Access Compliance Report

Public Rights-of-Way

Intersection ID: 12455	Main Street: E_3RD_ST	Cross Street: S_TRYON_ST	Location: S
ADA ID: 4E5894777DD0	Ramp Type: PerpDiag	Initial Pass/Fail: Fail	Overall Compliance: No
			Severity Score: 26.25

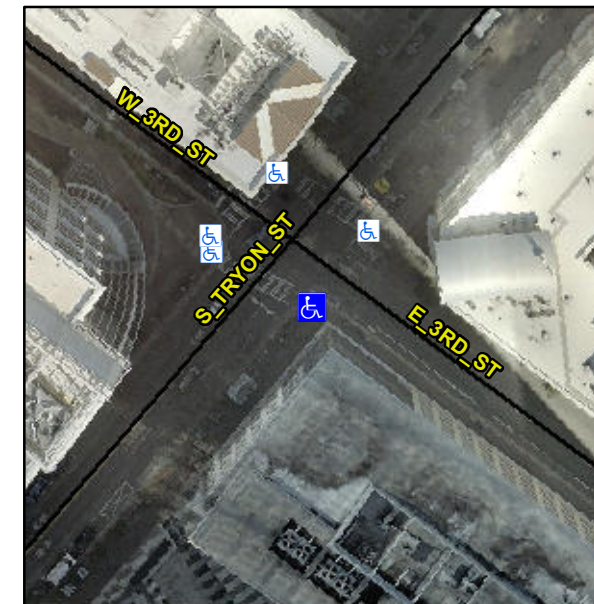
R304.2.2, R304.5.3

Compliance	Description	Data	Compliance	Description	Data
N/A	Ramp Length (in)	24.0	No	Ramp Slope (%)	12.8
Yes	Ramp Width (in)	64.0	No	Ramp XSlope (%)	3.3
N/A	Flare Type LT	N/A	N/A	Flare Type RT	N/A
N/A	Flare Slope LT (%)	N/A	N/A	Flare Slope RT (%)	N/A
N/A	Flare Traversable LT?	N/A	N/A	Flare Traversable RT?	N/A
N/A	Landing Length (in)	N/A	N/A	DWS Provided?	N/A
N/A	Landing Width (in)	N/A	N/A	DWS Contrast?	N/A
N/A	Landing Slope (%)	N/A	N/A	DWS Length (in)	N/A
N/A	Landing X Slope (%)	N/A	N/A	DWS Full Width?	N/A
N/A	Landing Curb? (Y/N)	N/A	N/A	DWS Offset (in)	N/A
N/A	Shared Landing?	N/A			
N/A	Gutter Ponding?	N/A	N/A	Gutter Slope (%)	N/A
N/A	Gutter Lip Ht (in)	N/A	N/A	Gutter X Slope (%)	N/A
N/A	Painted X Walk1?	Yes	N/A	Painted X Walk2?	Yes
	X Walk 1 Direction	To NE		X Walk 2 Direction	To NW
N/A	X Walk 1 Width (in)	168.0	N/A	X Walk 2 Width (in)	108.0
	X Walk 1 Slope (%)	3.8		X Walk 2 Slope (%)	0.9
	X Walk 1 X Slope (%)	0.7		X Walk 2 X Slope (%)	0.3

Remove & Replace Curb Ramp With Two New Directional Ramps or Equivalent.
